Response For FCC Application 2005/6/14

RE: Benq

FCC ID: JVP57P50

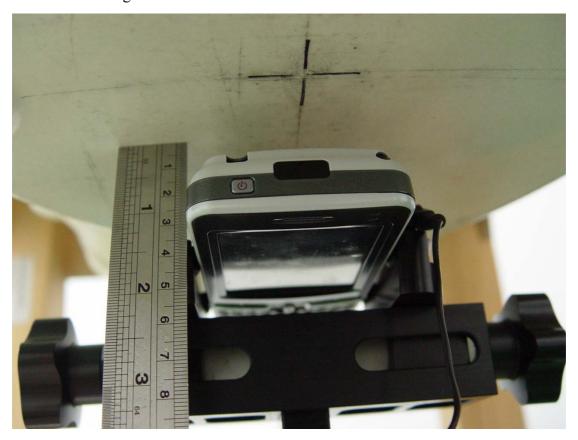
1. Please find the SAR setup photo with 1.5 cm gap configuration as attached.
